Access Compliance Report

Public Rights-of-Way

(Curb Ramps)

Intersection ID: 15175	Main Street: SOUTH_BV	Cross Street: POINDEXTER_DR	Location: NW
ADA ID: 376007C7B416	Ramp Type: Perp	Initial Pass/Fail: Fail	Overall Compliance: No
			Severity Score: 13.75

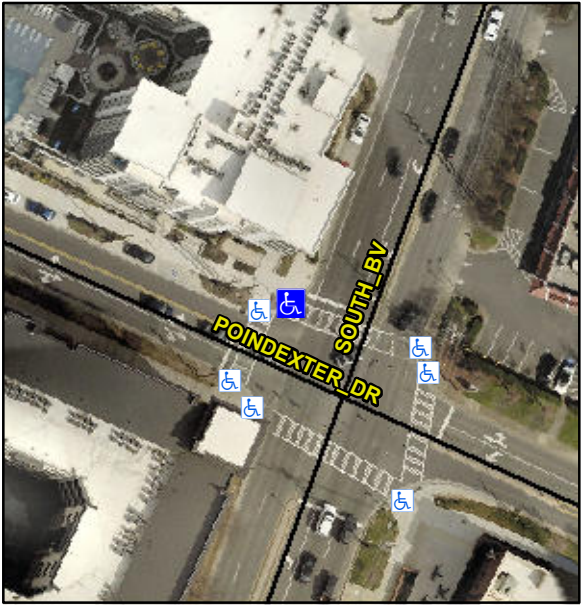
Codes/Mitigation Info/Possible Solution			Field Measurements/Component Compliance		
	Possible Solutions:		Compliance	Description	Data
	Remove & Replace Entire Ramp.		No	Ramp Length (in)	93.0
			Yes	Ramp Width (in)	49.0
			N/A	Flare Type LT	N/A
			N/A	Flare Slope LT (%)	N/A
			N/A	Flare Traversable LT?	N/A
			N/A	Landing Length (in)	N/A
			N/A	Landing Width (in)	N/A
			N/A	Landing Slope (%)	N/A
			N/A	Landing X Slope (%)	N/A
<p>Surveyor Notes:</p> <p>N/A</p> <p>PROW/ADA:</p> <p>Not Found, R304.2.2</p>			N/A	Flare Type RT	N/A
			N/A	Flare Slope RT (%)	N/A
			N/A	Flare Traversable RT?	N/A
			N/A	DWS Provided?	N/A
			N/A	DWS Contrast?	N/A
			N/A	DWS Length (in)	N/A
			N/A	DWS Full Width?	N/A
			N/A	DWS Offset (in)	N/A
			N/A	Shared Landing?	N/A
			N/A	Gutter Ponding?	N/A
			N/A	Gutter Lip Ht (in)	N/A
			N/A	Painted X Walk1?	Yes
				X Walk 1 Direction	To SE
			N/A	X Walk 1 Width (in)	104.0
				X Walk 1 Slope (%)	1.4
				X Walk 1 X Slope (%)	4.3

N/A	Ramp inside XWalk1?	Yes
			N/A	Road Slope (%)	N/A
			N/A	Road X Slope (%)	N/A
			N/A	Any Obstructions?	N/A
				Obstruction Type	
			N/A		
			N/A		
			N/A		
			N/A		
			N/A		
			N/A		
			N/A		
			N/A		
			N/A		
Total Cost:		\$ 1850.00			
			N/A		
			Yes	Surface Condition? (G/P)	Good
